AFFORDABLE HOUSING
DEVELOPMENT SSD-83256463
ARCHITECTURAL DRAWINGS
THE BOULEVARDE
PUNCHBOWL
COLLINS AND TURNER
SEPTEMBER 2025

No	Date	By	Note
B	9/12/2025	DC	For RTS

Project	
Affordable Housing Development SSD-83256463 150 The Boulevard and 34 Dudley Street Punchbowl, NSW

Drawing Title South and East Elevation

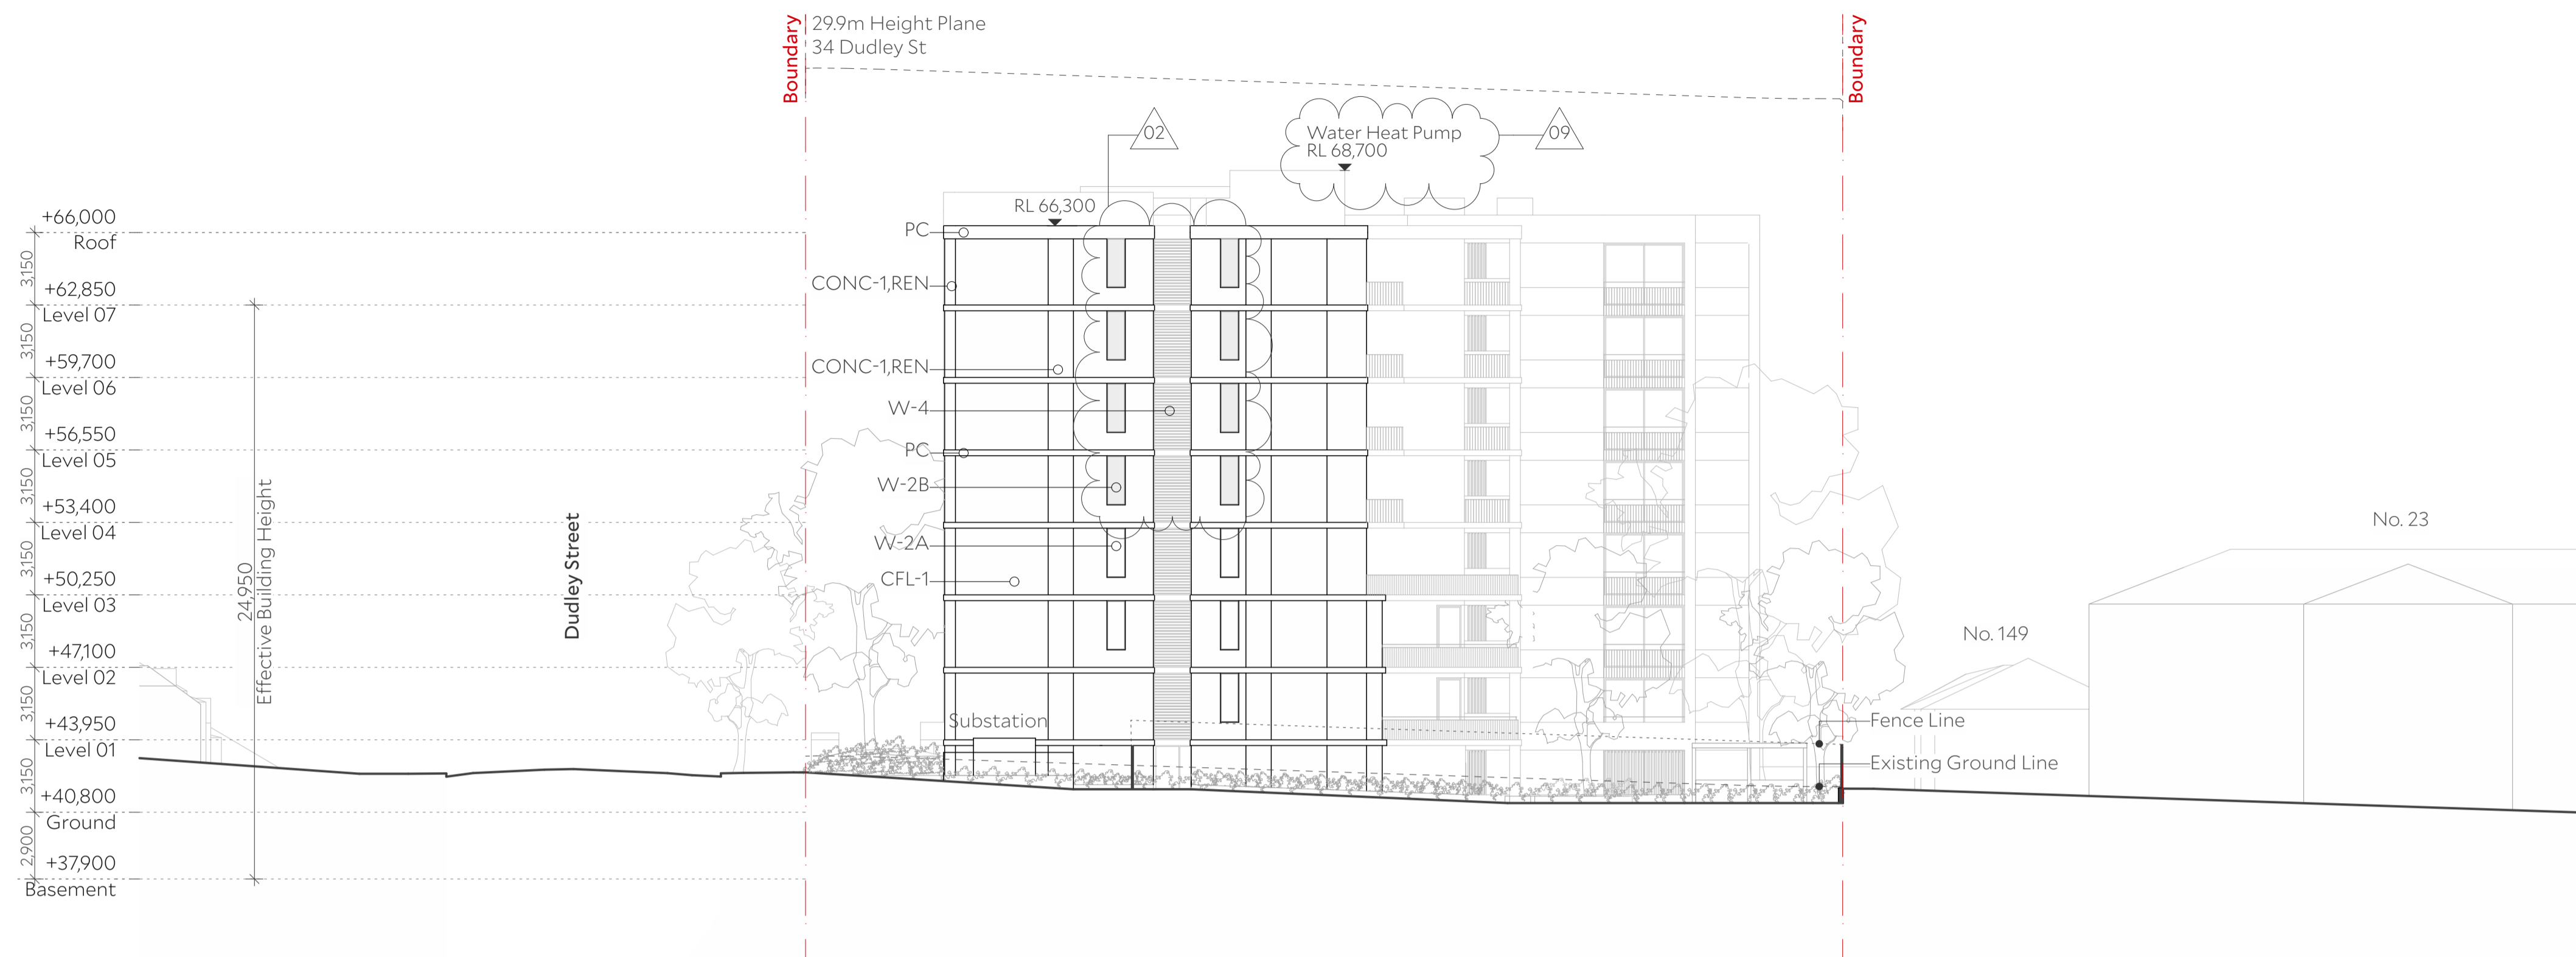
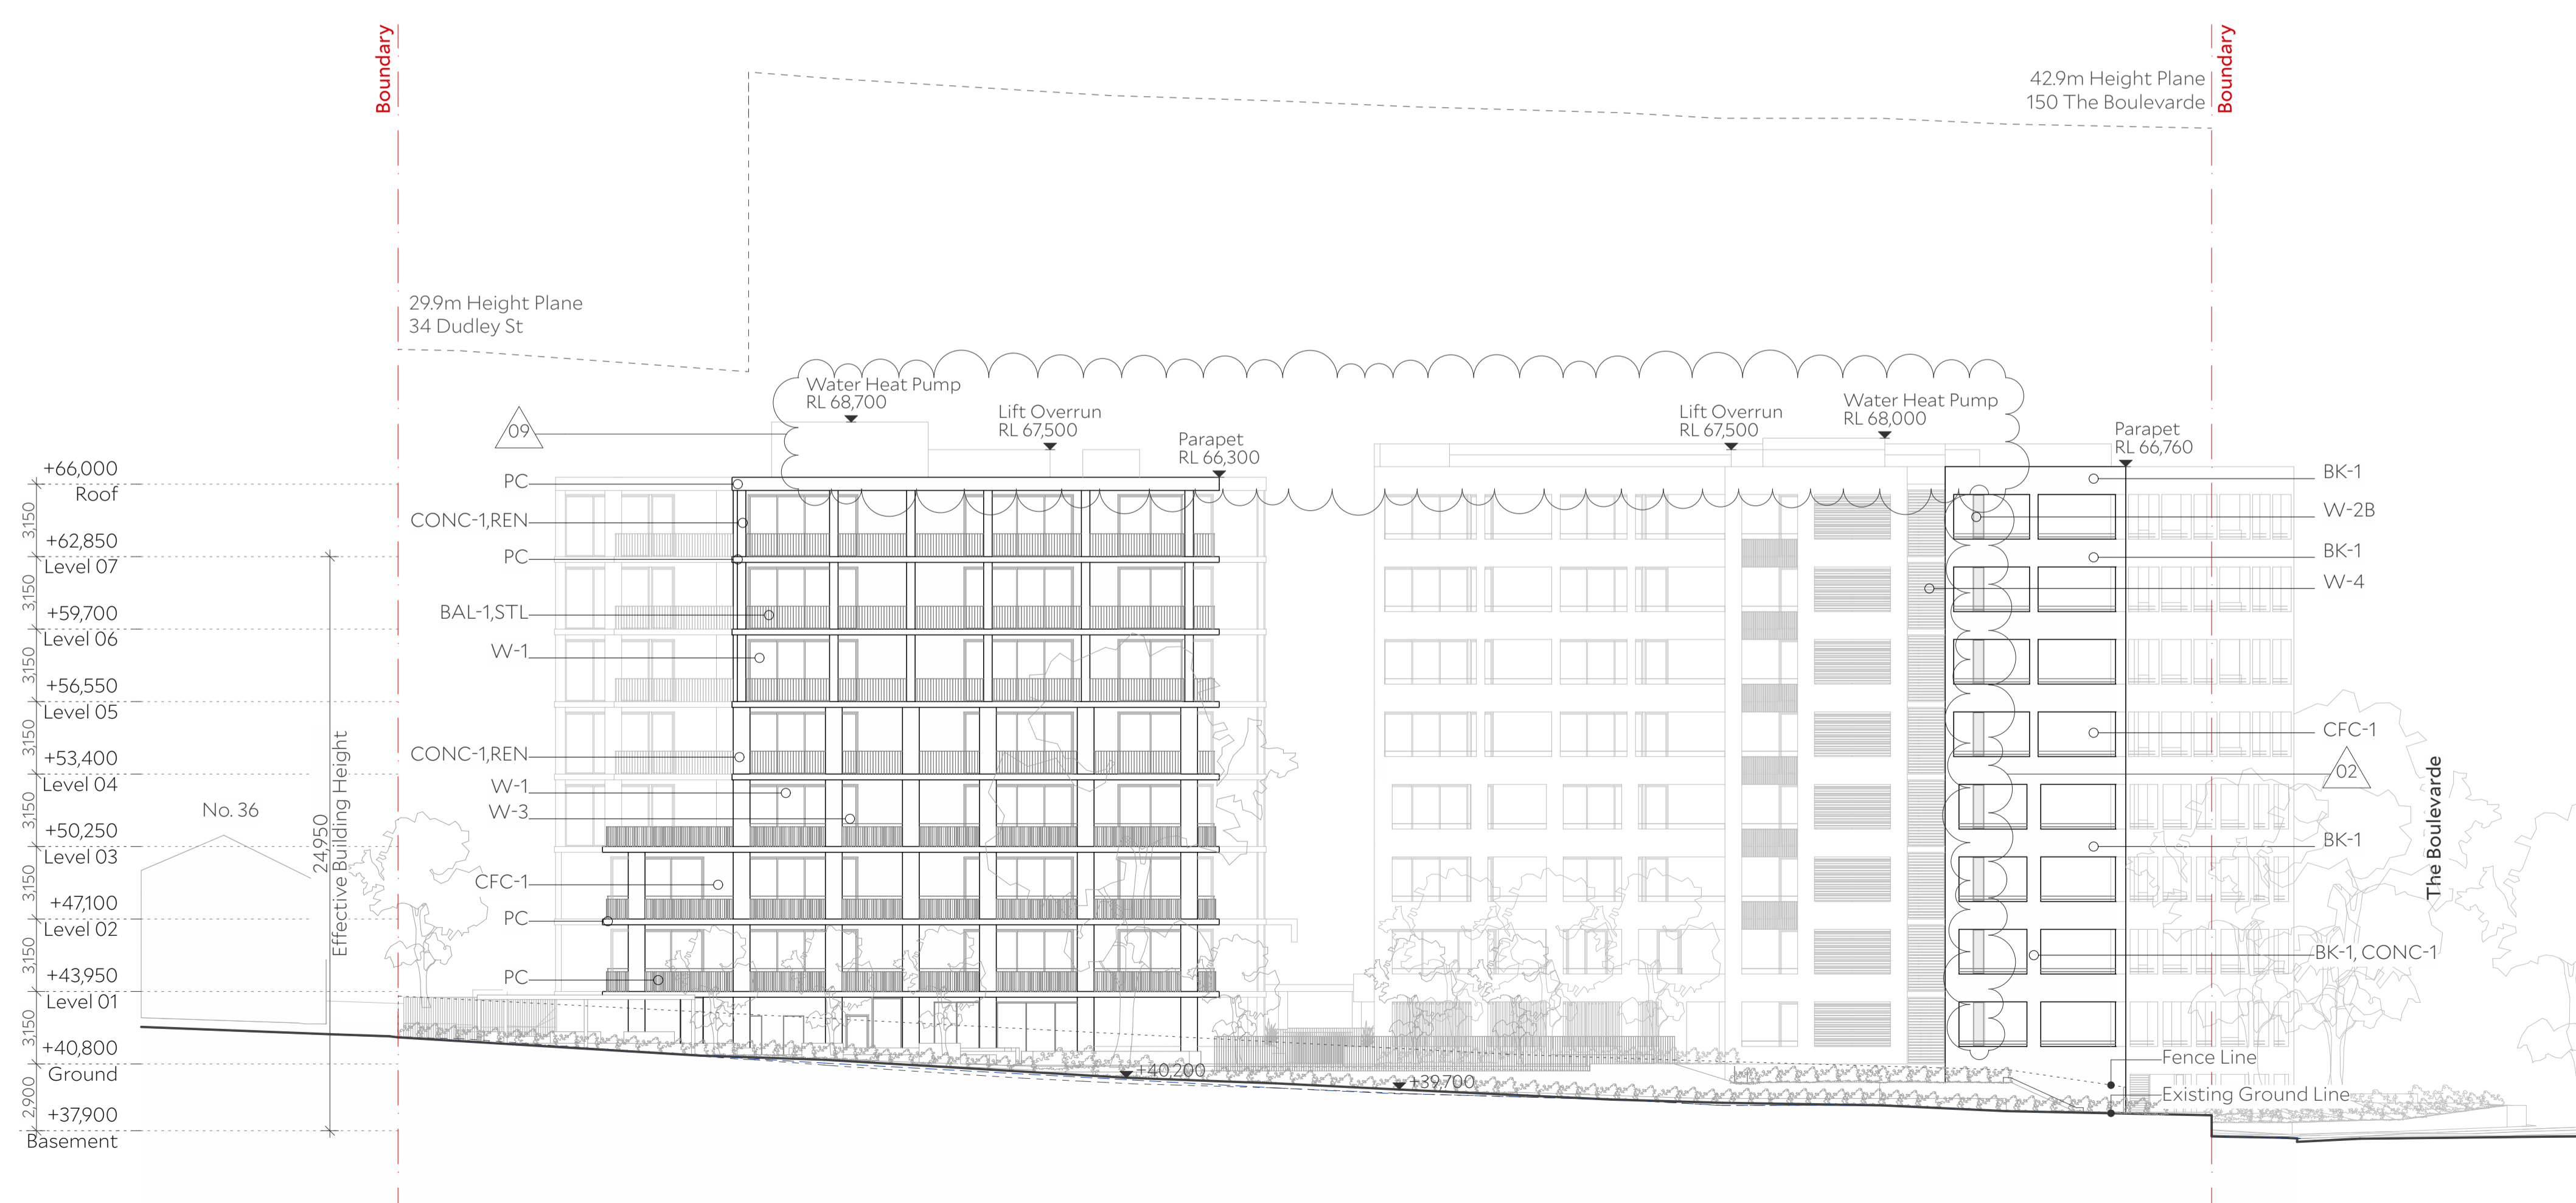
ID	Name
02	Glazing finish adjusted Refer to RTS Item DPHI 3-4, CB-UD21
09	Reduced levels added Refer to RTS Item DPHI 14

Drawing Title Internal Building A and B
Elevation

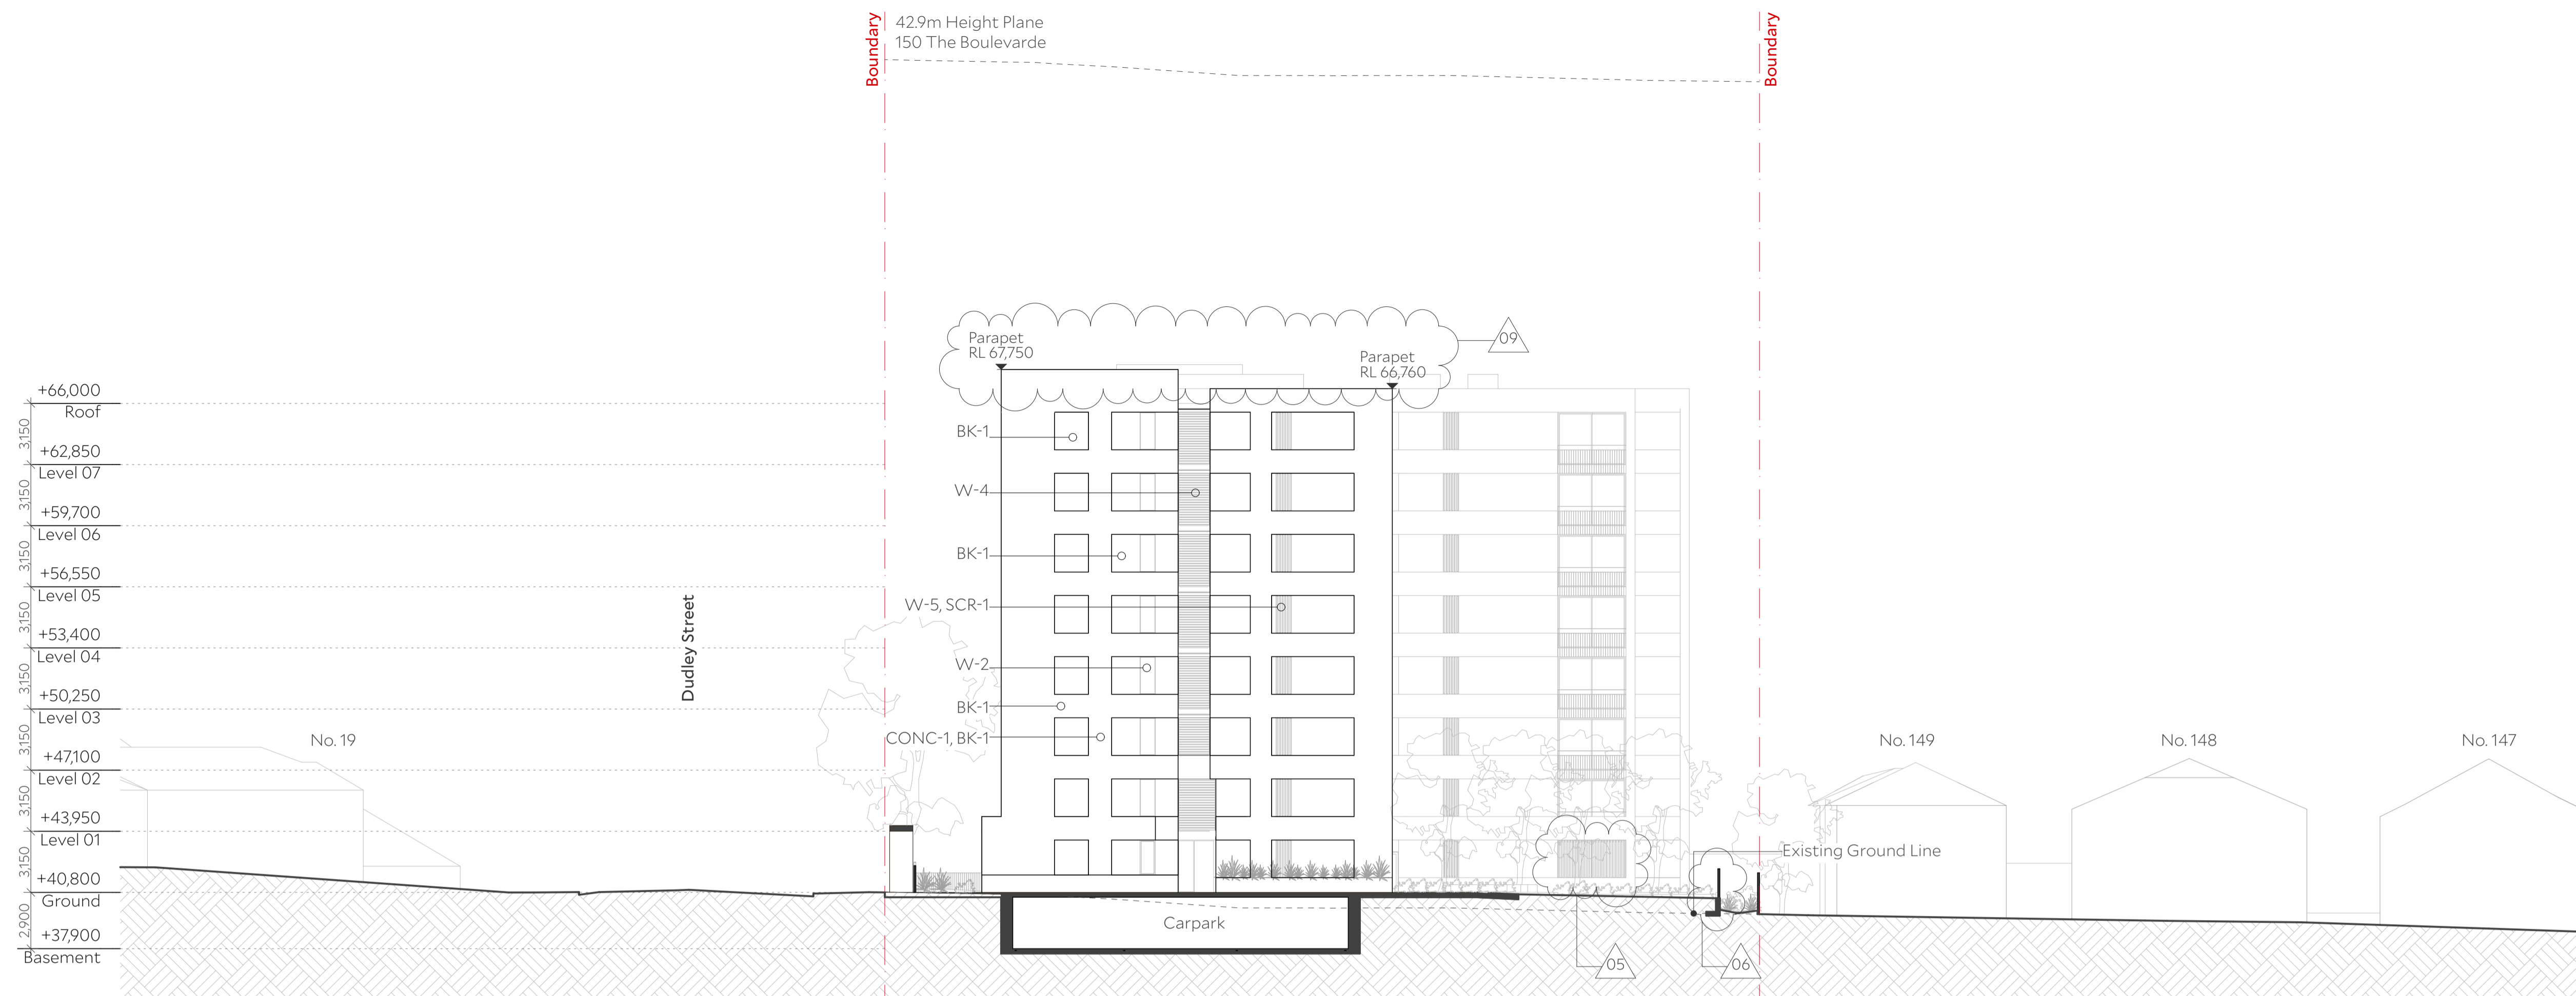
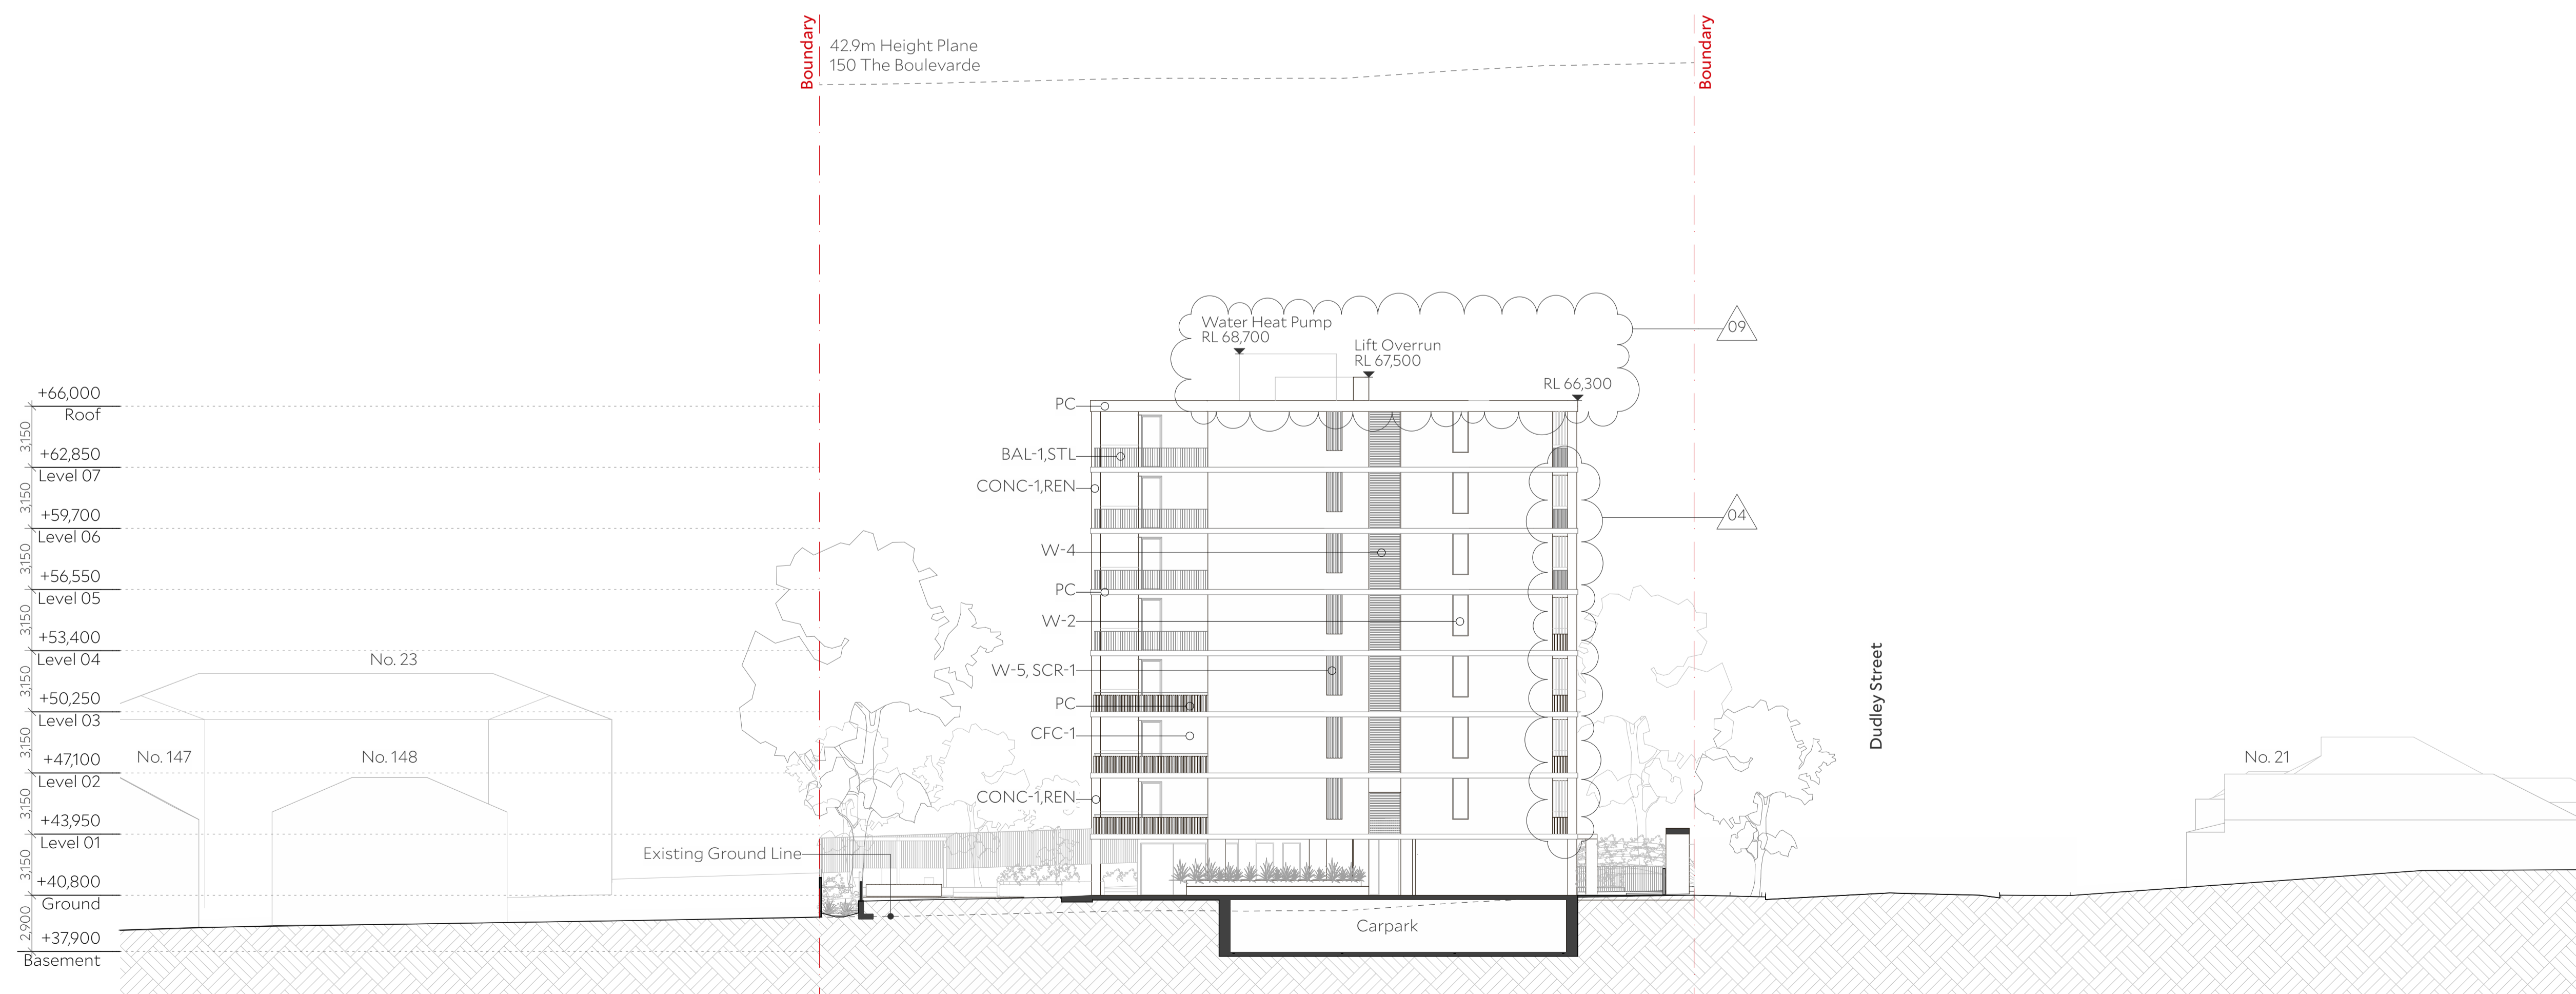
ID	Name
04	Facade opening added Refer to RTS Item DPHI 6
05	Privacy screens added and pathway repositioned Refer to RTS Item DPHI 7
06	Landscape privacy screen added Refer to RTS Item DPHI 8
09	Reduced levels added Refer to RTS Item DPHI 14
